**THE CITY OF WINNIPEG**  
WATER AND WASTE DEPARTMENT

COMMUNITY ROW WASTEWATER PUMPING STATION  
2017 UPGRADES  
PLAN  
MECHANICAL  
MAIN FLOOR, MOTOR ROOM & PUMP ROOM - DEMOLITION

CITY DRAWING NUMBER: 1-0130L-M0001 SHEET: 001 REV.: 01 SIZE: A1

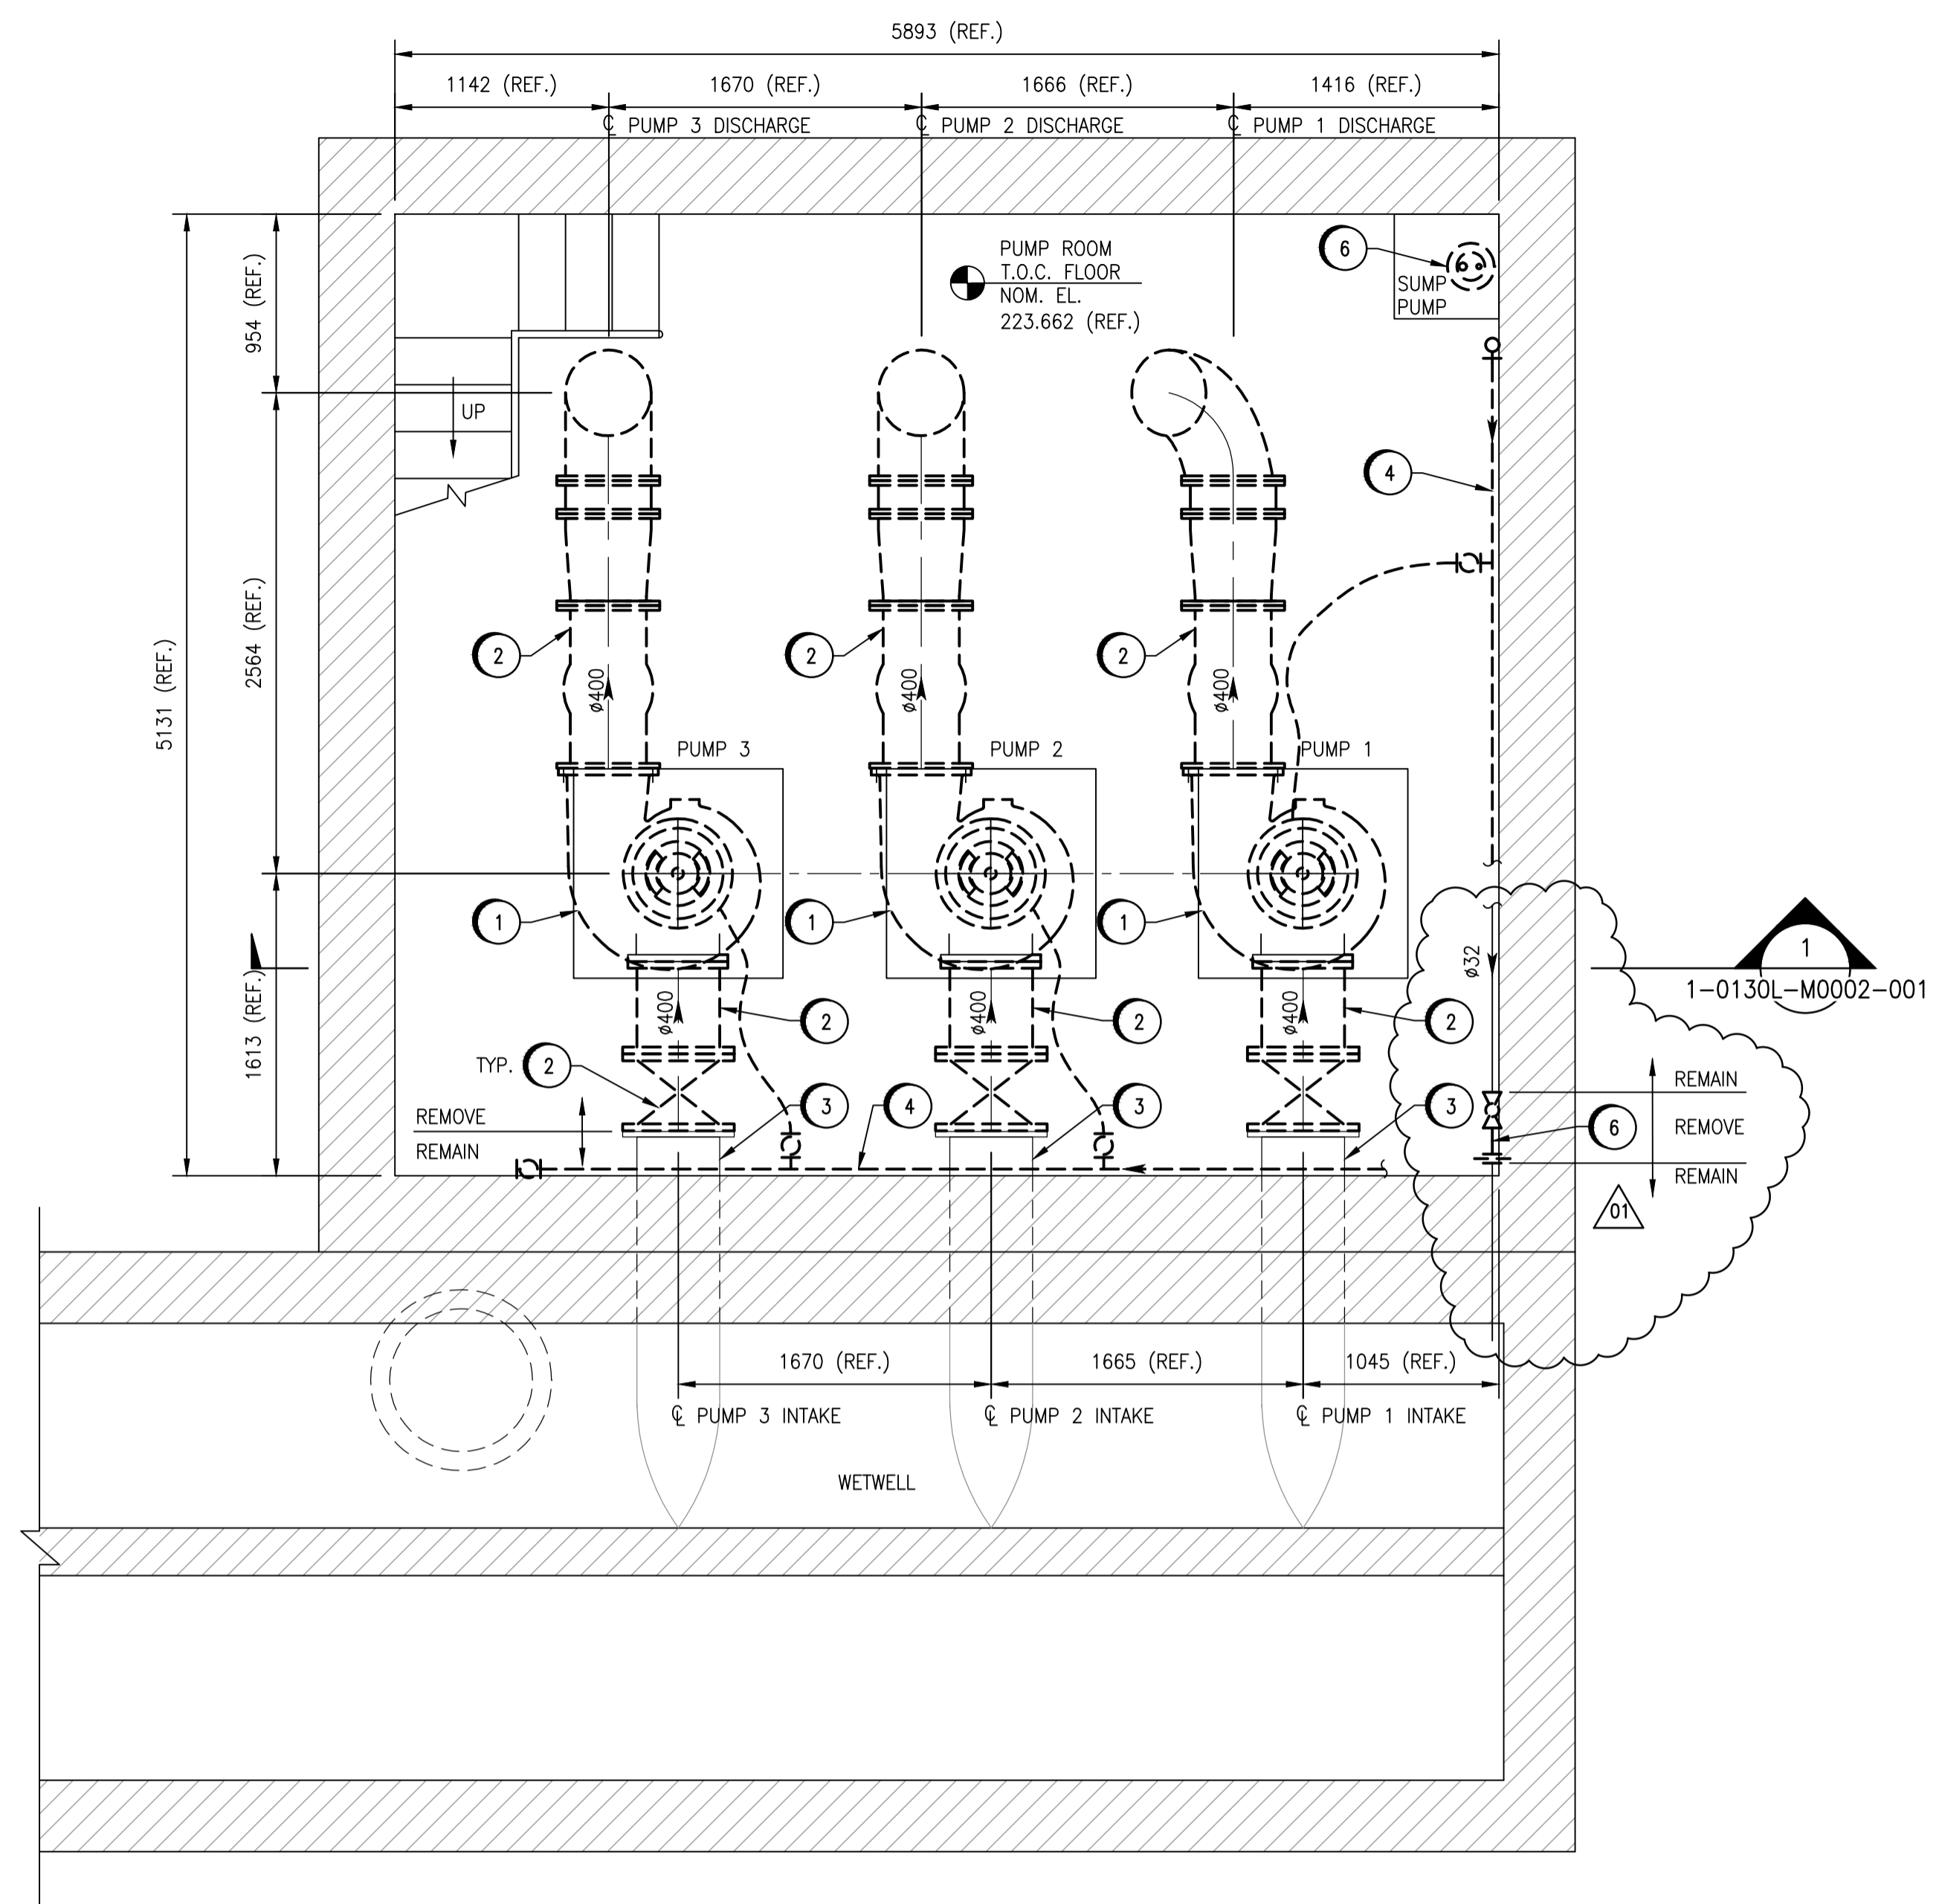
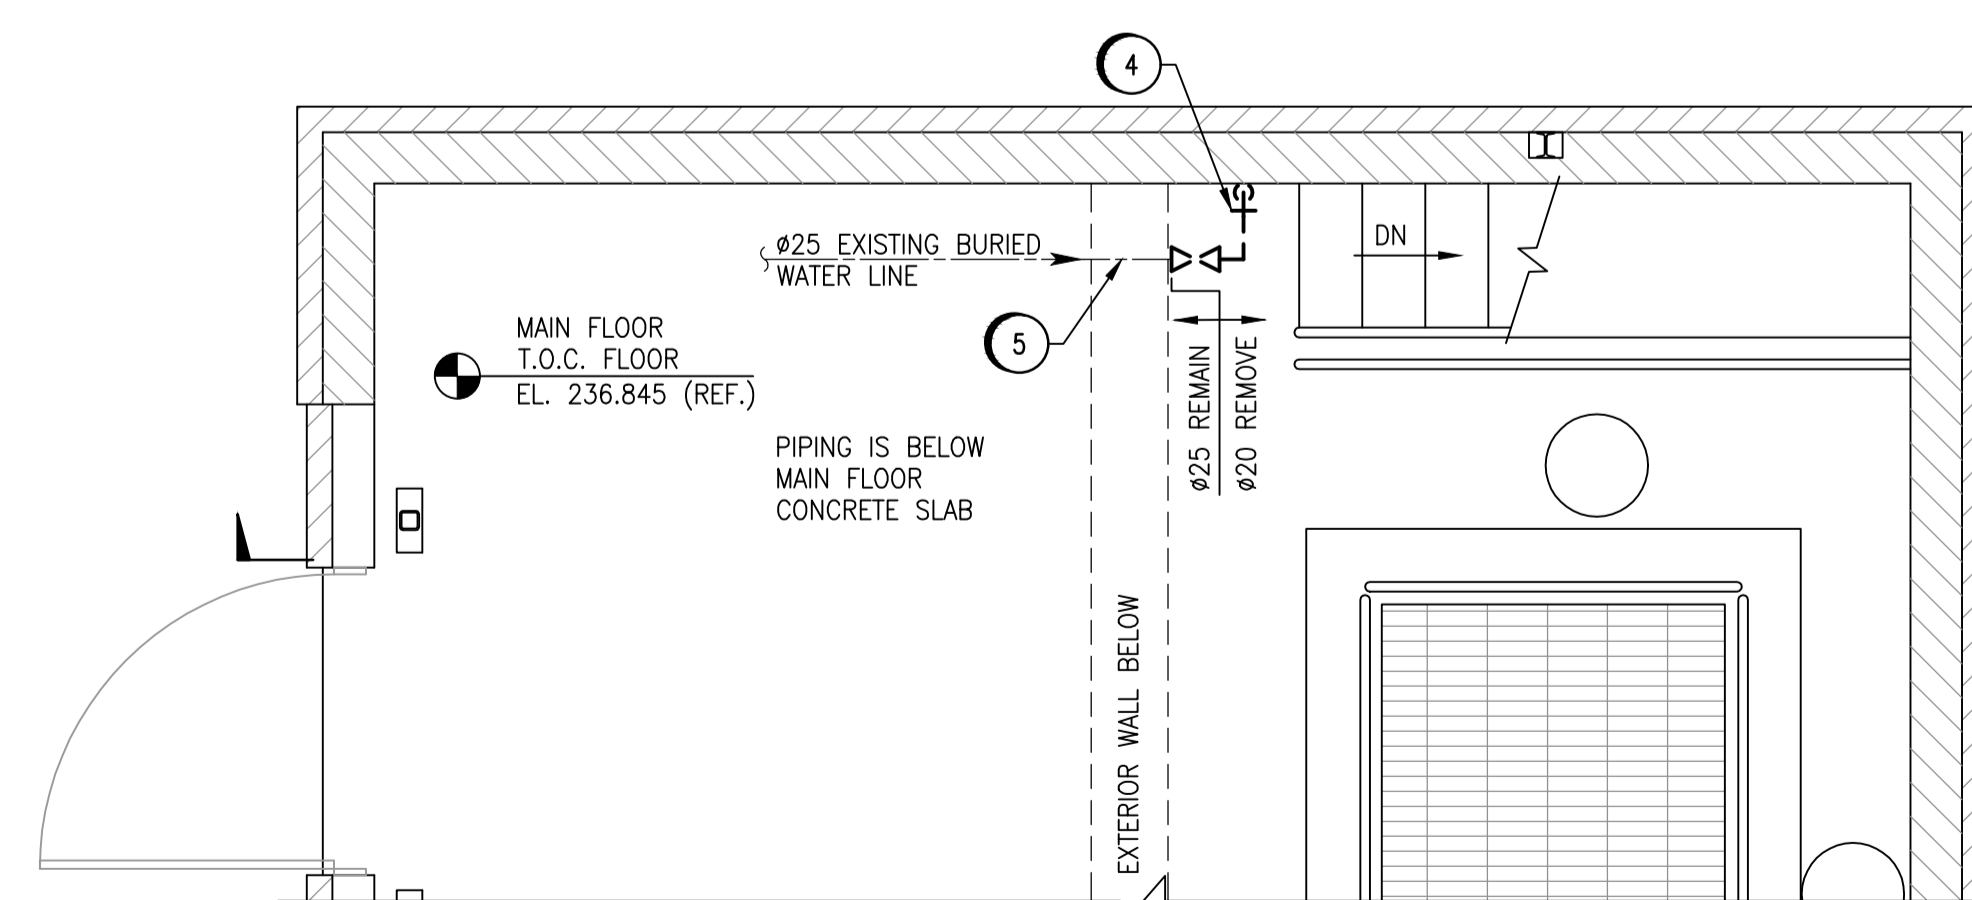
NO.	REVISIONS	DATE	DESIGN	CHECK
01	ADDENDUM #2 - REVISE SUMP PIPING	2017-08-09	FZ	BJC
00	ISSUED FOR TENDER, BID OPP. 639-2017	2017-07-25	FZ	BJC
